Dear Examiner,

At the last meeting I made representation that I think that the emissions from the potential Plant that you are considering have been under estimated and that this as a consequence means that the stack height calculation has been underestimated.

Chart 1 – NO<sub>x</sub> Start Up Emissions

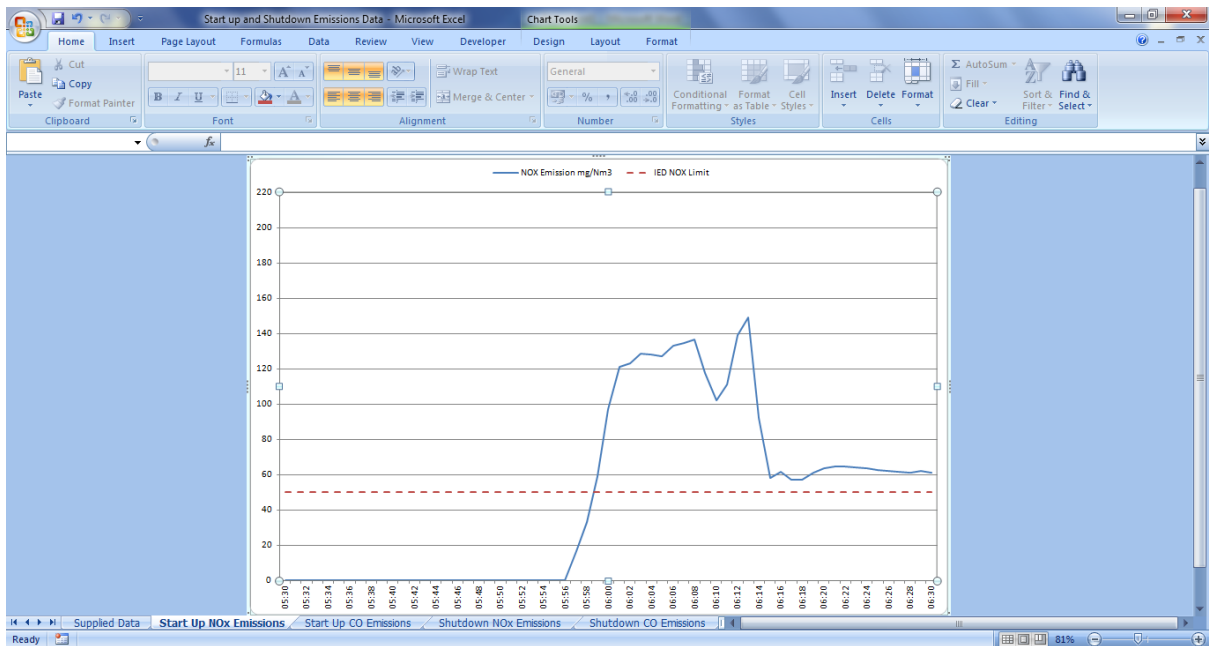
You can clearly see that during both of these periods that both compounds exceed their respective emission limits, CO quite considerably.

You may also note that after the start up and prior to the shutdown periods the NOx emissions are constantly above the Plant limit.

The maximum value for NOx in the start up data is  $148.9\text{mg}/\text{Nm}^3$ . However it is feasible that this value once the C.I. has been returned then it is  $186.1\text{mg}/\text{Nm}^3$ . However, if this value with the C.I. returned was under estimated by 20%, for reasons previously explained, then this maximum value could conceivably be  $232.6\text{mg}/\text{Nm}^3$ .

### Chart 2 – CO Start Up Emissions

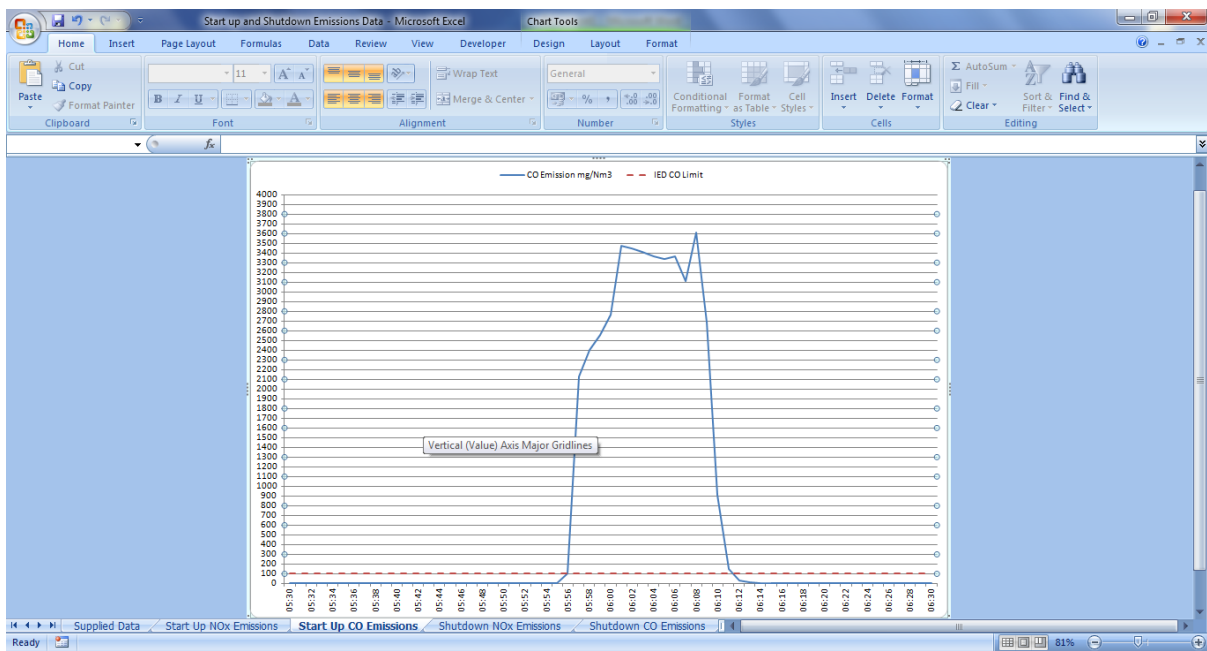
The maximum value in the CO start up period is  $3610\text{mg}/\text{Nm}^3$ . When both 10% reductions have been returned, then this value is  $445\text{mg}/\text{Nm}^3$ .

### Chart 3 – NOx Shutdown Emissions

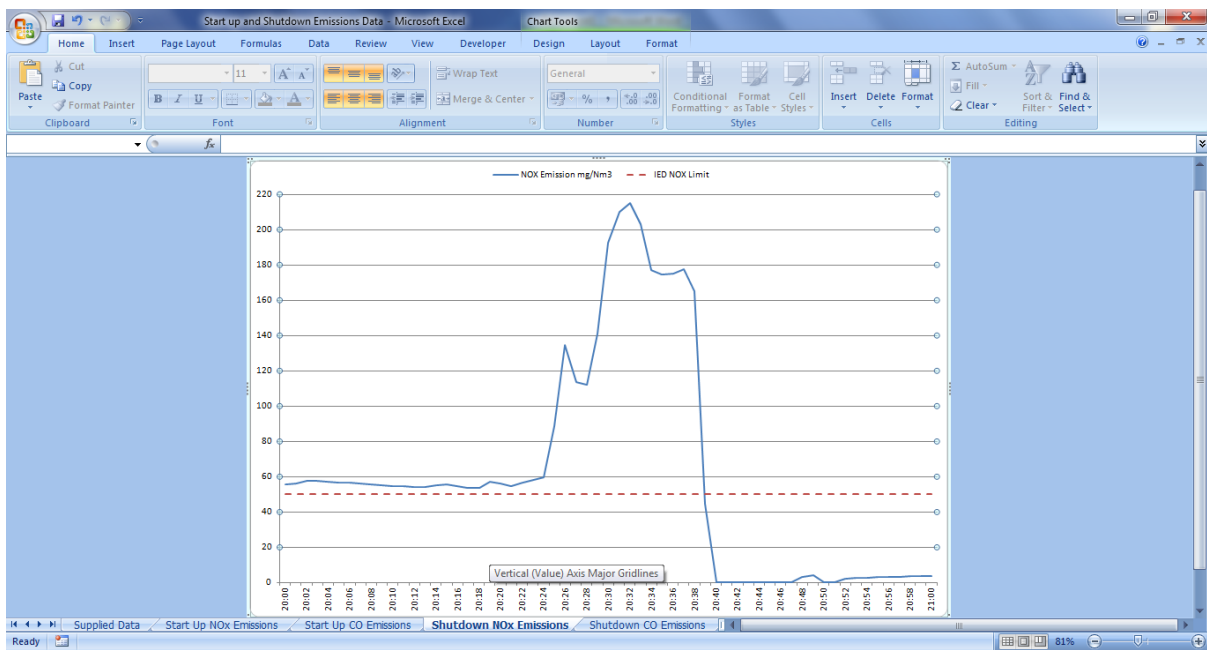
The maximum value for NOx during the shutdown period is  $215.2\text{mg}/\text{Nm}^3$ . When both 20% are returned to this figure, then it becomes  $336.2\text{mg}/\text{Nm}^3$ .
